HCS362 Data Sheet Errata

Clarifications/Corrections to the Data Sheet:

In the Device Data Sheet (DS40189D), the following clarifications and corrections should be noted.

FIGURE 3-3: TRANSMISSION FORMAT (PWM)

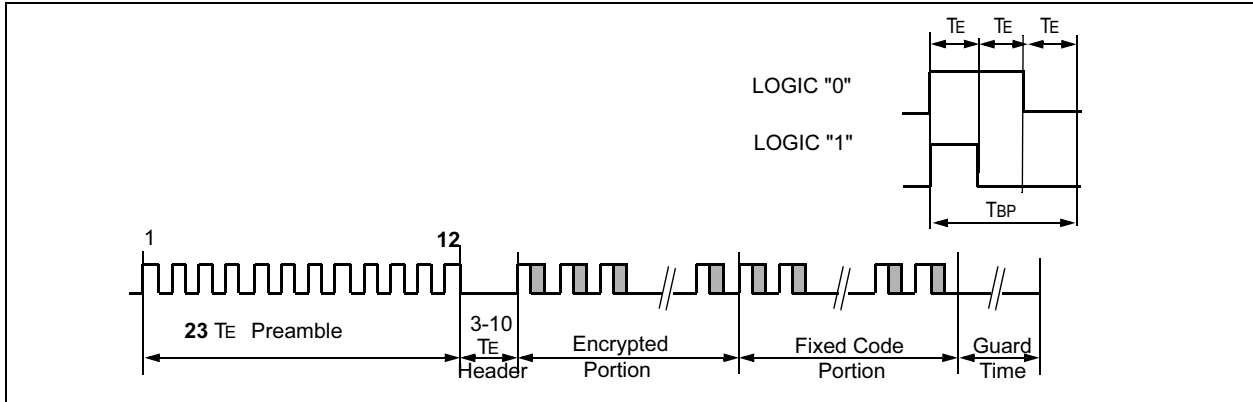
Corrections to Figure 3-3 and 3-4, page 9. Clock count should be 12 not 16, and 31 TE preamble should be 23 TE preamble.

FIGURE 3-5: CODE WORD DATA FORMAT CONFIGURATION WORDS

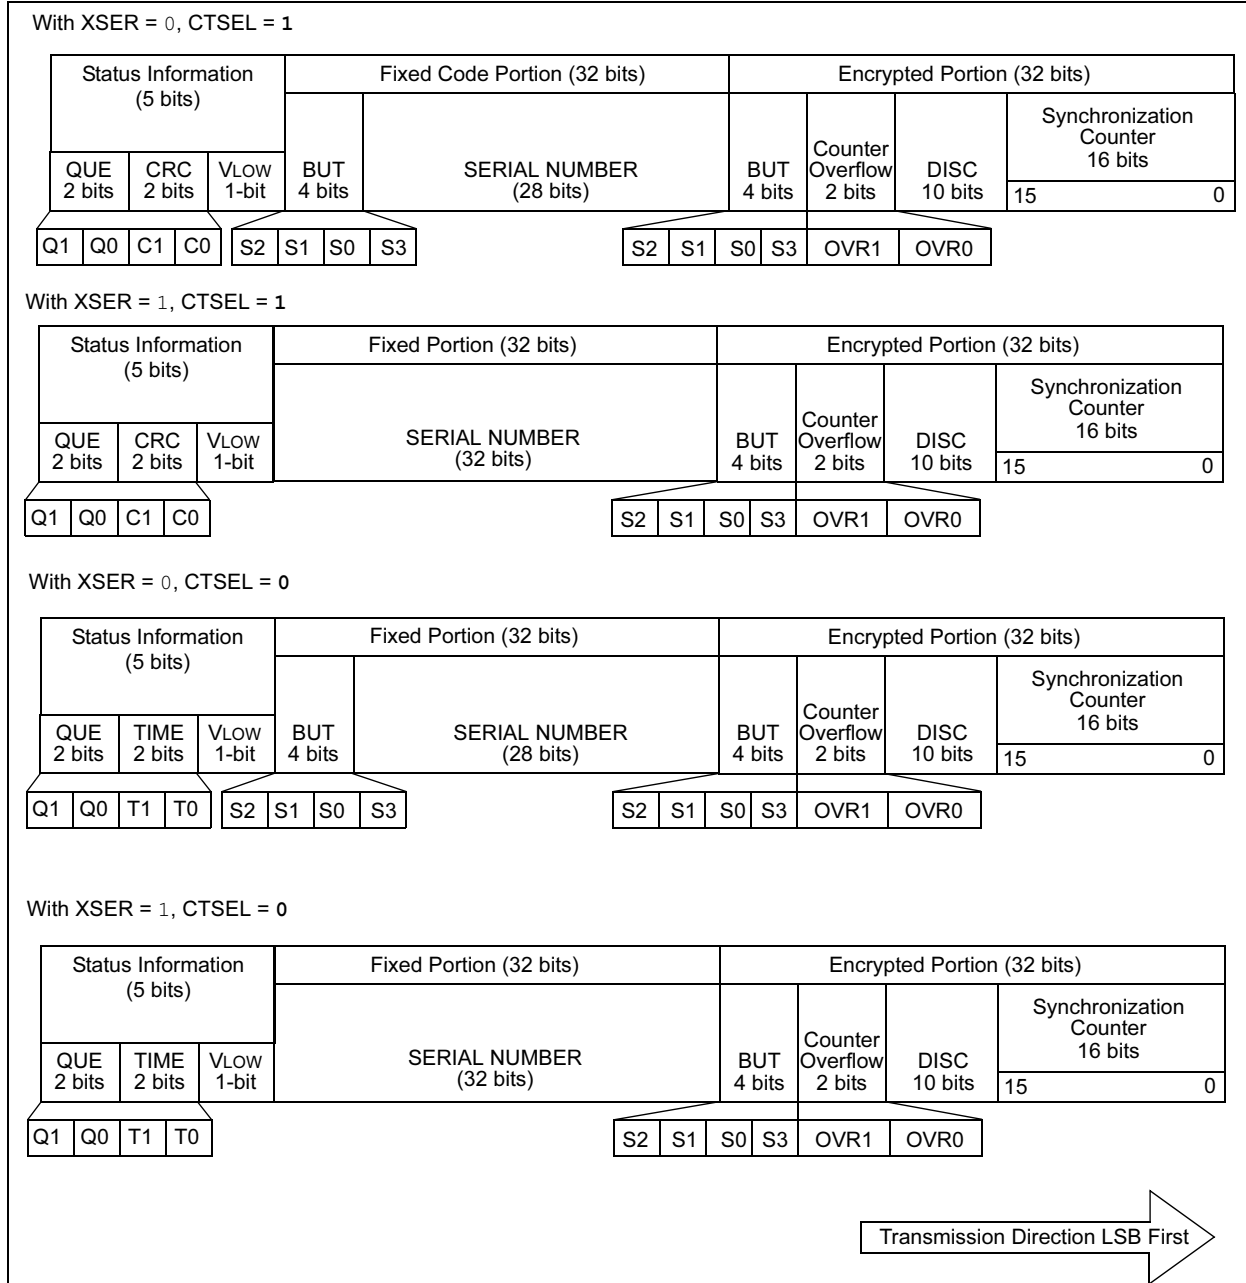
Corrections to Figure 3-5, page 11. The CTSEL bit values should be changed as follows:

- XSER = 0, CTSEL = 0 to CTSEL = 1
- XSER = 1, CTSEL = 0 to CTSEL = 1
- XSER = 0, CTSEL = 1 to CTSEL = 0
- XSER = 1, CTSEL = 1 to CTSEL = 0

FIGURE 3-7: LED OPERATION (LED = 1)

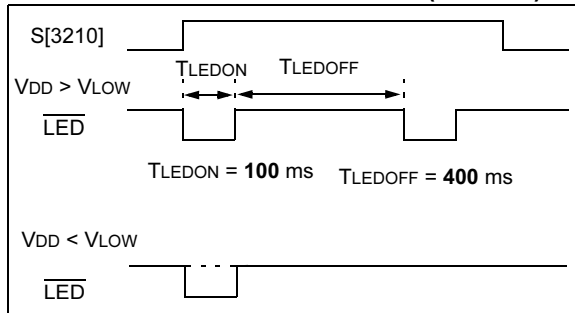
Corrections to Figure 3-7, page 12. The duty cycle TLEDON should be 100 ms not 25 ms and TLEDOFF should be 400 ms not 500 ms.

FIGURE 3-8: LED OPERATION (LED = 0)

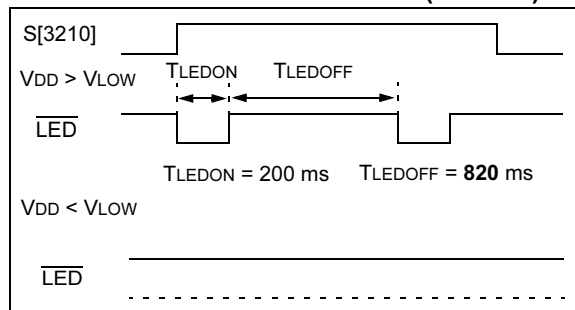
Correction to Figure 3-8, page 12. Duty cycle TLEDOFF should be 820 ms not 800 ms.

FIGURE 7-2: PWM FORMAT SUMMARY (MOD=0)

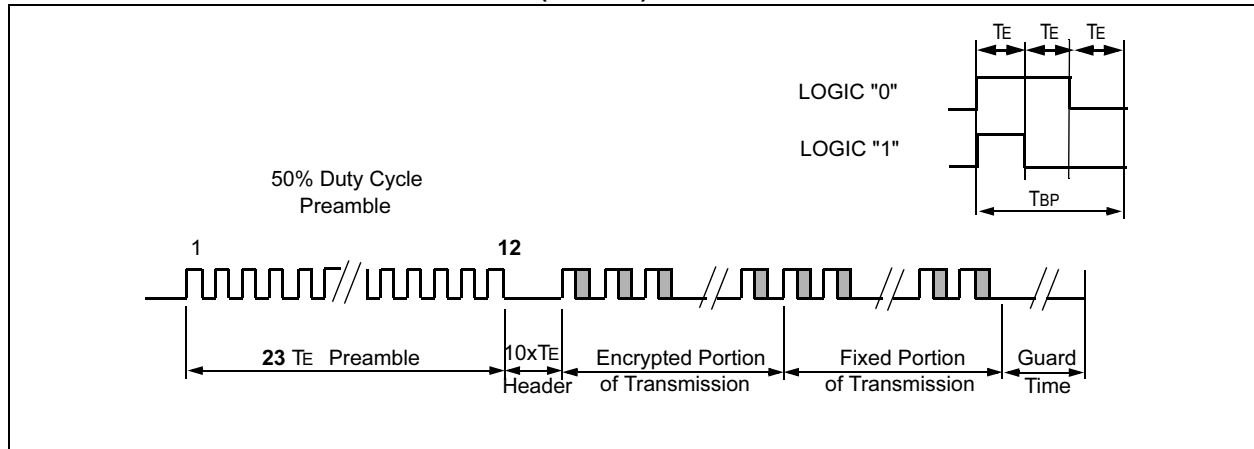
Corrections to Figure 7-2, 7-3, 7-5 and 7-6, page 27 and 28. Clock count should be 12 not 16, and 31 TE preamble should be 23 TE preamble.

FIGURE 2-3: HCS362 TE VS. TEMPERATURE

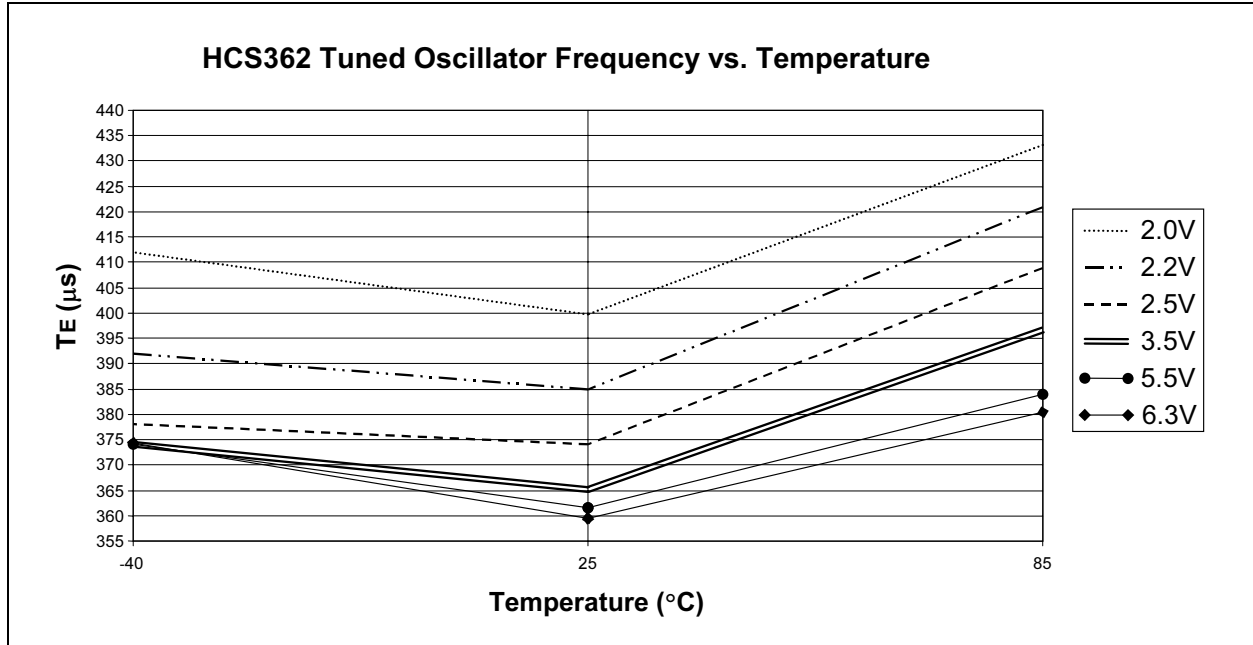
Corrections to Figure 2-3: HCS362 Normalized TE vs. Temperature. Replace Figure 2-3 with the figure below.
